Our ref 258354-00

Digital Netherlands VIII B.V
Planning Ref. No. SD21A/0217

Clarification Request 2 i

Figure 1 - Roadside Swale Treatment Train

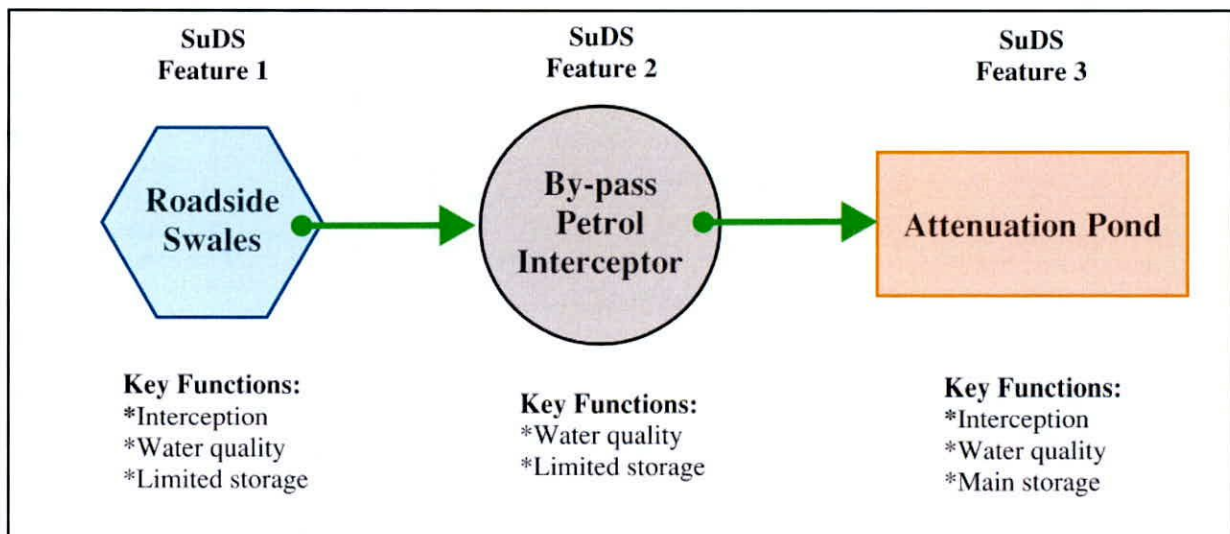
- i. How much surface water attenuation in m³ is provided by SuDS features.
- ii. It is unclear where treatment train is provided with SuDS or how SuDS are connected to each other.
- iii. Where are the flow controls in SuDS.
- iv. Where SuDS can provide surface water attenuation examine if hard engineering structures such as gullies and surface water pipes can be reduced or removed.
- v. Show on a drawing a cross section of proposed SuDS systems. Examples of SuDS can be viewed in a SuDS Guide obtained on South Dublin County Council Website.
- vi. Submit a report and drawing to clarify what areas are draining to proposed pond. Does proposed pond only take surface water from areas within red line boundary or does it also take surface water from DUB 13 and DUB 14.

As part of the surface water drainage design for the proposed site we have incorporated the following treatment train as illustrated in the schematic SuDS layout below.
